**CITY OF GRANT  
PLANNING COMMISSION MEETING**

# PLANNING COMMISSION MEETING MINUTES CITY OF GRANT

**Re:** *Farms of Grant Preliminary Development Plan - Engineering Review*

Figure 1: Full Right Turn Lane Treatment.

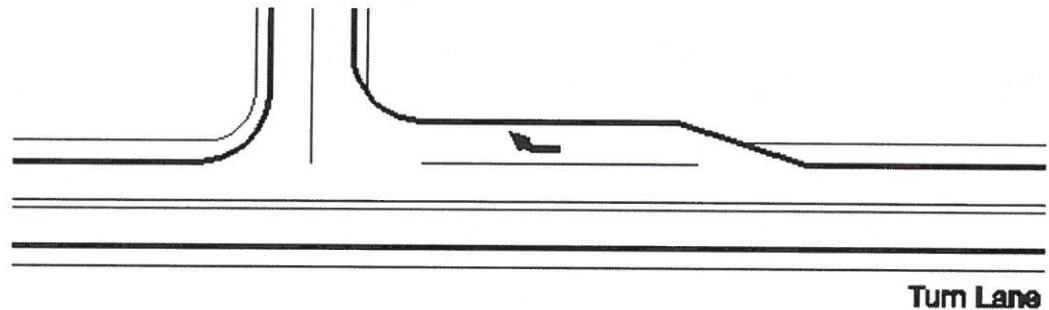
- Adding full right turn lanes to northbound Lake Elmo Avenue at Street A, as shown in Figure 1 below.

Figure 3: Strengthened Right Turn Lane Treatment.

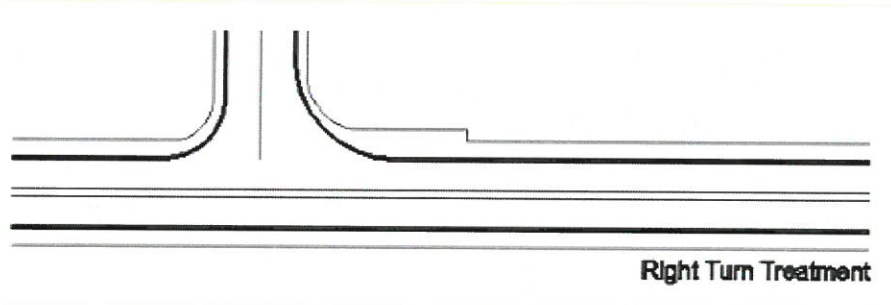
- Strengthening and expanding the shoulder for eastbound traffic at 75<sup>th</sup> Street at Street A for eastbound vehicles, as shown in Figure 2, below. Due to the low volume of vehicles making right-turning movements into the development an expanded and strengthened shoulder will allow the turning vehicles to shift out of the through lane and make a safe right turning movement without blocking through moving vehicles. In addition, sufficient right-of-way should be set aside to expand to a standard turn lane if and when additional development and future traffic growth occurs.
